# UNITED STATES PATENT AND TRADEMARK OFFICE

APPLICATION NO.	FILING DATE	FIRST NAMED INVENTOR	ATTORNEY DOCKET NO.	CONFIRMATION NO.
10/525,967	07/29/2005	Rowan Dallimore	034369-006	3172
55694	7590	11/07/2008		
DRINKER BIDDLE & REATH (DC) 1500 K STREET, N.W. SUITE 1100 WASHINGTON, DC 20005-1209			EXAMINER	
			MILLER, BEN A B	
			ART UNIT	PAPER NUMBER
			3725	
			MAIL DATE	DELIVERY MODE
			11/07/2008	PAPER

<b>Office Action Summary</b>	<b>Application No.</b> 10/525,967	<b>Applicant(s)</b> DALLIMORE ET AL.
	<b>Examiner</b> Bena Miller	<b>Art Unit</b> 3725

**DETAILED ACTION**

Figure 15 of Lusty

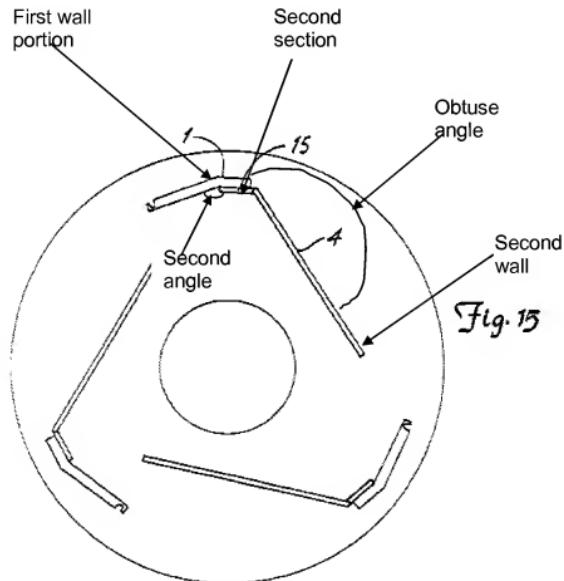
The device of Lusty reads on the claimed invention including rotor (fig.15) comprising a horizontal upper disc and a horizontal lower disc, said discs being separated by at least two vertical wall segments defining between them an outflow opening for material leaving the rotor, said wall segments each having a first wall portion (1) being substantially tangential in relation to the rotor and being located adjacent to the periphery of the rotor and a second wall portion (4) being angled in relation to said first wall portion (fig. 15) and extending from the first wall portion into the rotor , wherein characterized in that said second wall portion comprises a straight first section (fig. 5) extending from the interior of the rotor towards the periphery of the rotor, said first section forming an obtuse first angle with said first wall portion (see marked copy fig. 15), and a second section connecting the first section and the first wall portion, said second section and said first wall portion forming a second angle (see marked copy fig. 15) being smaller than said first angle, said second section and said first wall portion forming at least one pocket for retaining material. Also, a second pocket is formed

between the first and second section as seen in the figure 15 of Lusty. Further, the examiner takes the position that the first angle of Lusty is approximately  $130^\circ$  and the second angle of Lusty is approximately  $94^\circ$

Applicant's arguments filed 07/10/08 have been fully considered but they are not persuasive. Applicants argue Lusty fails to teach the end of the second section contacts an end of the first wall portion and the second section is oriented in a radial direction. The examiner contends the second portion is "oriented" in a radial since it connects to the first wall portion at an angle. Lusty meets the claimed limitations. In response to applicants' argument that Lusty fails to meet the claimed second angle, the examiner disagrees. As seen in the marked copy Figure 15 of Lusty, the examiner second angle

as indicated falls within the claimed range. Therefore, the examiner maintains Lusty meets the claimed limitation.

Applicants also argue that it would not have been obvious to modify the device of Lusty to meet the claimed angle of the second angle. It should be noted Lusty teaches in paragraph 1 and 2 of column 5, teaches the angle of tip 5 is altered relative to the material build up. Therefore, the examiner contends it would have been obvious to modify the device of Lusty to meet the claimed angle.
